Work Order ID 159802***159802***

Item ID: D5162-041 **Accept** ***N900040100*** **Setup** **Start** ***NS1***
Revision ID: **Stop** ***NS2***
Item Name: Seat Structure Assembly
Start Date: 4/24/2017 **Start Qty:** 1.00 ***1*** **Cust Item ID:**
Required Date: 5/1/2017 **Req'd Qty:** 1.00 ***1*** **Customer:**
Reference: SCHEDULED/C
Approvals: **Process Plan:**  **Date:** APR 18 2017 **Tooling:** **Date:**
QC: **Date:** **SPC (Y/N):** **Date:** **Run** **Start** ***NR1***
Stop ***NR2***

DESIGN CP	DRAWN BY CP	DART AEROSPACE LTD HAWKESBURY, ONTARIO, CANADA	
CHECKED #	APPROVED #	DRAWING NO. D3016	REV. A SHEET 1 OF 3
DATE 01.05.18		TITLE SEAT FRAME ASSEMBLY	SCALE NTS
A	01.05.18	NEW ISSUE

DRAWING NO. D3016	TITLE SEAT FRAME ASSEMBLY	REV. A	DART AEROSPACE LTD ENGINEERING ORDER	D.E.O. NO. D3016-A-1	SHEET NO. SHEET 1 OF 1	SCALE NTS
DRAWN 1	CHECKED UP	MFG. APPR. R	APPROVED WAP	DE APPR. #		
DATE 10.01.29	DATE 10.01.29	DATE 10.01.29	DATE 10.01.29	DATE 10.01.29

D3016-11 SADDLE

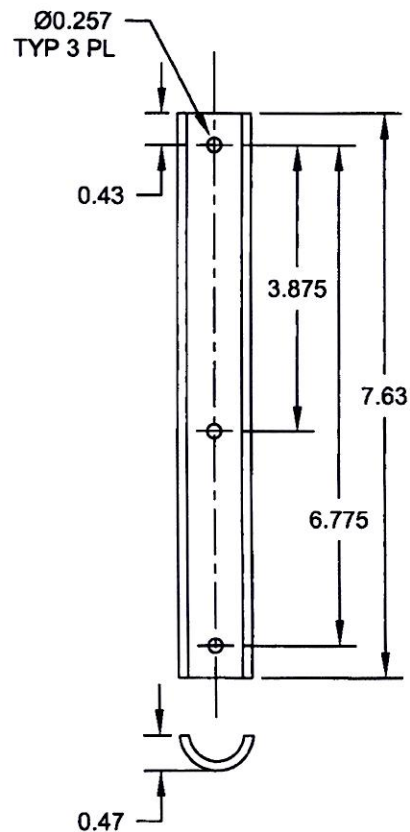
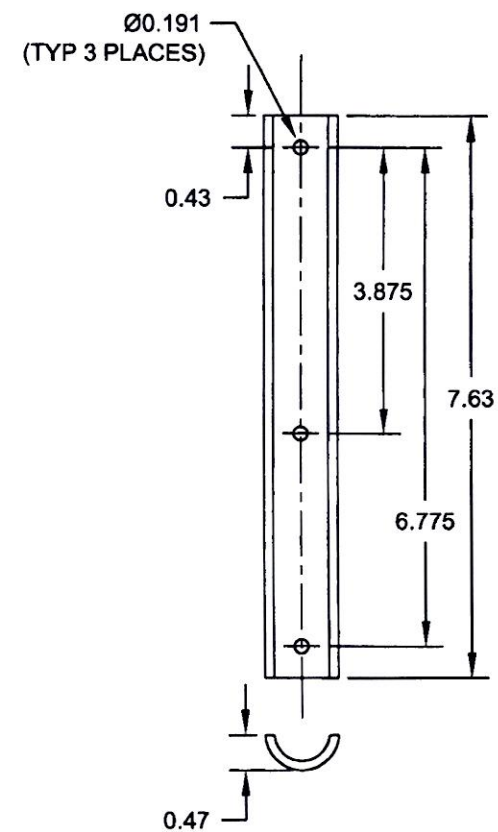
PURPOSE:

TO REVISE D3016-11 SADDLE'S HOLE SIZES

DETAIL D3016-11 SADDLE (SHEET 3): Ø0.257 TYP 3 PL WAS Ø0.191 (TYP 3 PLACES) AS SHOWN:
